SUMMARIZATION OF NEW APPENDICES (B, C, D, E, F, G, H, I)

DATE: June 15, 2026

RE: Supplemental Public Comments and Risk Assessment regarding the Proposed 20 MGD Wastewater Treatment Facility

LOCATIONS UNDER CONSIDERATION: Sites 1 through 7 — Mann Road, Berea Church Road, and Coles Ferry Pike corridor, Lebanon, TN

Exhibit C-1: 0.5-mile, 1.0-mile, and 2.0-mile rings centered on 3230 Mann Road, plotted on the TDEC Water Wells Desktop Application map. Each dark dot represents a permitted private water well in the TDEC database.

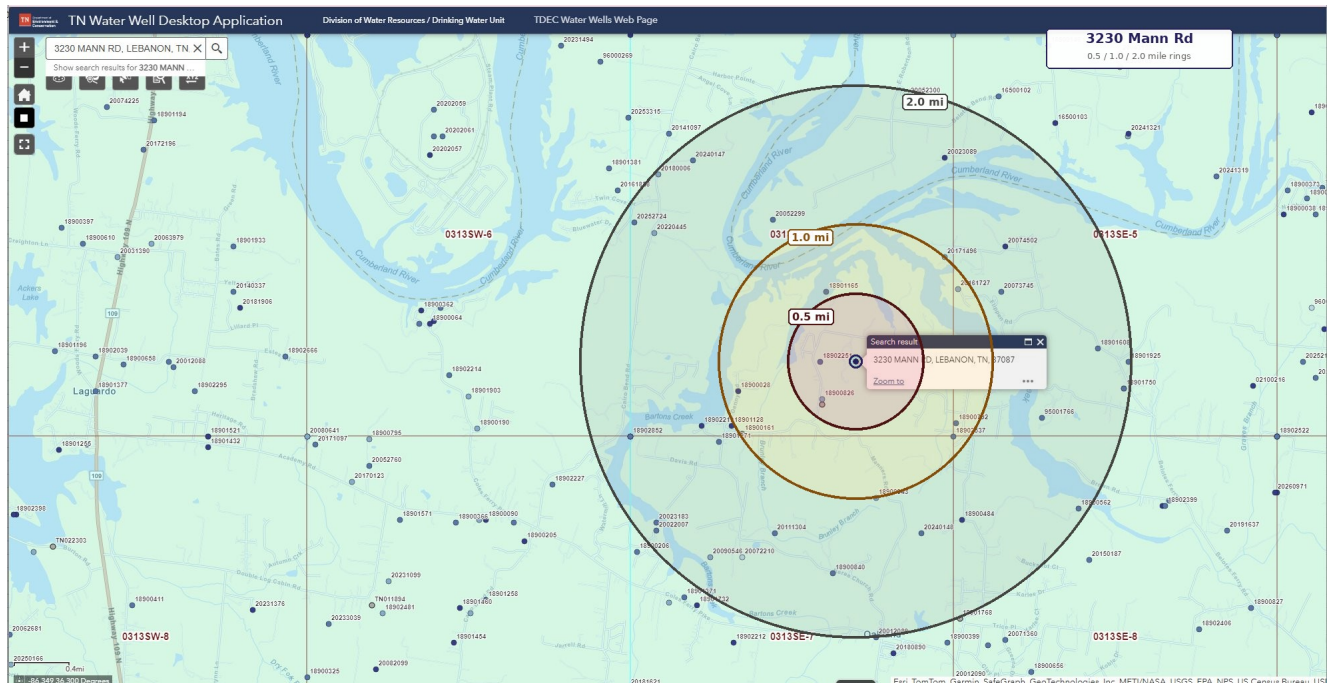
A query of the Tennessee Department of Environment and Conservation (TDEC) Water Well Locations public database identifies **a minimum of 38 permitted private wells within the 2-mile contamination radius** surrounding the proposed Mann Road and Berea Church Road footprint. Of these:

- **6 wells are located within 0.5 miles** of a proposed site, including a well at 1079 Berea Church Road (Coster) situated approximately 850 feet (0.16 mi) from the Mann Road site;
- **16 wells are located within 1.0 mile** of a proposed site;
- **38 wells are located within 2.0 miles** of a proposed site, the outer boundary of the karst contamination radius identified in Section VI.

The geographic distribution of these wells, with concentric 0.5-mile, 1.0-mile, and 2.0-mile rings, is depicted in Exhibit C-1 below. Recorded uses include residential drinking water (32 wells), agricultural and irrigation (9 wells), and geothermal heat pump (3 wells). The Site Selection Committee has not, to the petitioners' knowledge, entered these figures into the public record.

Important caveat: The figure of 38 wells is a minimum. The TDEC Water Well Locations database includes only those wells for which a licensed driller filed a report. Wells drilled prior to the

- Formally request a hydrogeological study from a qualified third party documenting (or refuting) hydraulic connectivity between the proposed site footprint and the LUD well field;
- Require coordination with the LaGuardo Utility District Board of Commissioners as a prerequisite to any further consideration of the Mann Road and Berea Church Road addresses;
- Enter the well-count data and accompanying ring map (Exhibit C-1) into the official public record of the site selection proceedings, and supplement it with an independent staff verification against the most current TDEC Water Well Locations database;
- Provide written notification to each identified well owner, and to all LUD ratepayers, of the proposed siting and the karst-aquifer contamination pathway described in Section VI of the principal statement.
